SUBJECT: VOGTLE ELECTRIC GENERATING PLANT, UNITS 1 AND 2 – FLOOD  
HAZARD MITIGATION STRATEGIES ASSESSMENT (CAC NOS. MF7987 AND  
MF7988)

STAFF ASSESSMENT BY THE OFFICE OF NUCLEAR REACTOR REGULATION  
RELATED TO MITIGATION STRATEGIES FOR  
VOGTLE ELECTRIC GENERATING PLANT, UNITS 1 AND 2  
AS A RESULT OF THE REEVALUATED FLOODING HAZARD  
NEAR-TERM TASK FORCE RECOMMENDATION 2.1- FLOODING

Figure 3.2.0-1. Site topographic map with FLO-2D model boundary and security barriers (taken from SNC (calc. package - VMSA-0040\_1-X2CA91\_Ver1\_0-VogtleLIPCalc).

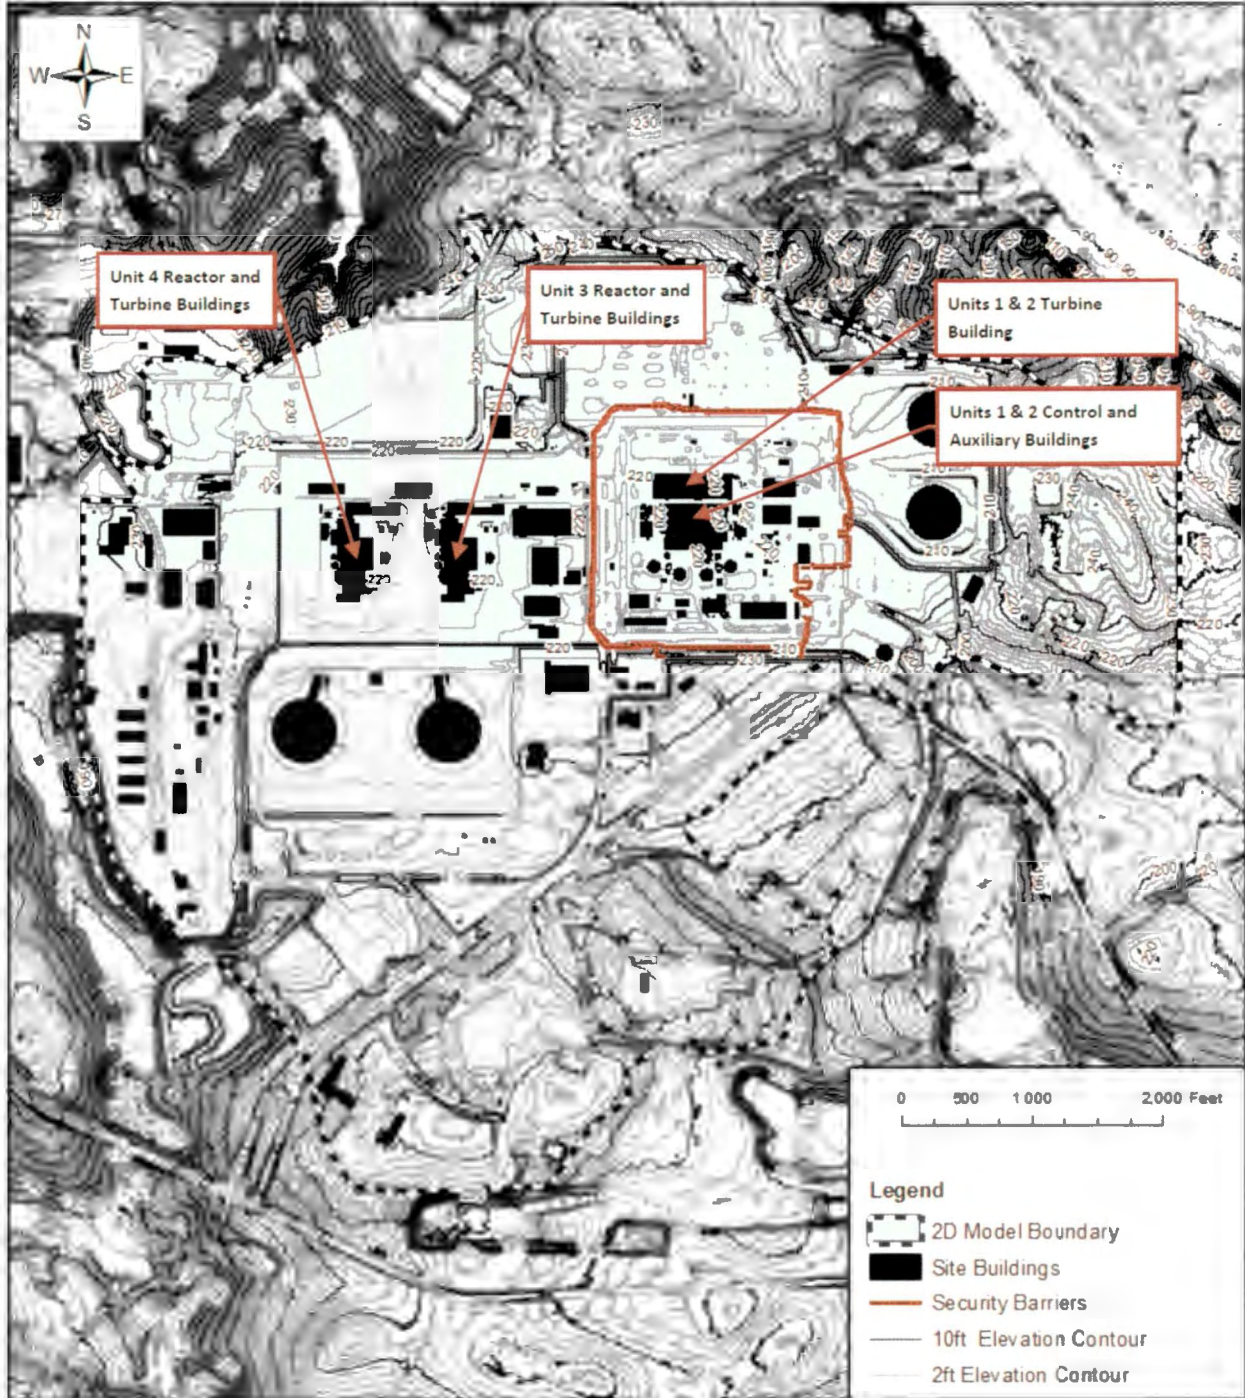
The licensee used the FLO-2D Pro Build No. 16.02.14 to simulate LIP-induced flood elevations. The computational domain of the LIP model encompasses the entire Vogtle site, including the Units 1 and 2 area, the Units 3 and 4 area, and the watershed basin contributing to the area surrounding to the plant (see Figure 3.2.0-1 of this assessment). A uniform 10-ft. square grid scheme was applied over the model domain, having a total of 380,895 grid cells. The licensee mentioned this grid resolution allowed for representing each building by at least one grid cell and enabled the representation of roads and channels adequately. The NRC staff confirmed based on a review of the Google maps that the licensee's model boundaries are adequate to capture the effects of runoff from the plant buildings and surrounding areas.

- The FLO-2D model was constructed using the current security barrier alignment surrounding Units 1 and 2 and the future site grading information for Units 3 and 4 as shown on Figure 3.2.0-1 of this assessment.

Figure 3.2.0-2. Map showing the maximum inundation depths for the LIP flood-causing mechanism using the FLO-2D model (taken from calc. package - VMSA-0040\_1-X2CA91\_Ver1\_0-VogtleLIPCalc).

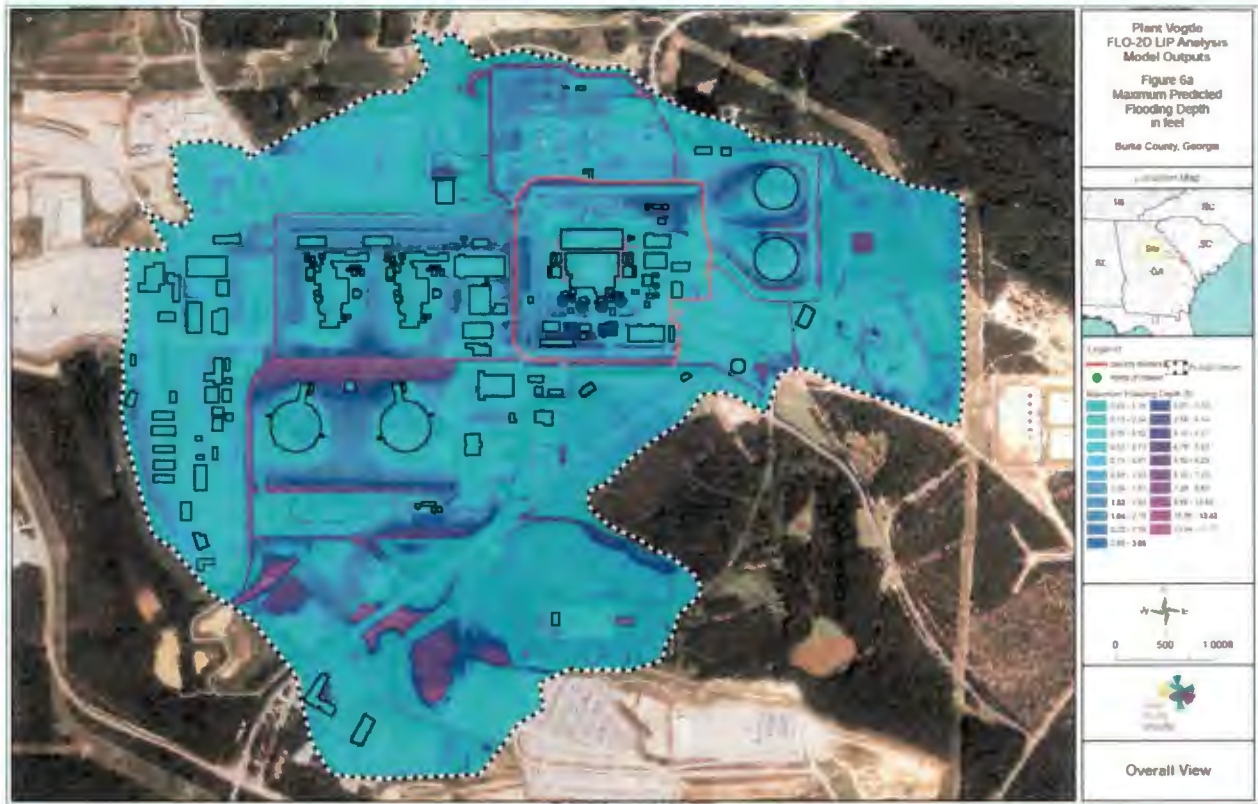
The licensee provided the maximum water surface elevations at selected monitoring locations near safety-related building doors (MSA Table 5-1) and at major haul pathways (MSA Table 5-2). Figure 3.2.0-2 of this assessment displays the spatial distribution of the maximum LIP flood inundation depths within the model area. The licensee reported a maximum LIP flood elevation within the power block area of approximately 220.5 ft. MSL. This maximum flood level would occur at the CST Valve Gallery Doors for both Units 1 and 2 (see Figures 3.2.0-3 and 3.2.0-4 of this assessment).

The NRC staff reviewed the licensee-provided LIP FLO-2D model output files and confirmed the maximum flood elevations reported in the MSA. The staff performed a confirmatory run of the licensee-provided FLO-2D model and found no significant numerical instability in its solution or any water budget errors. Therefore, the staff conclude that the licensee's updated LIP flood modeling is acceptable for use in the MSA.
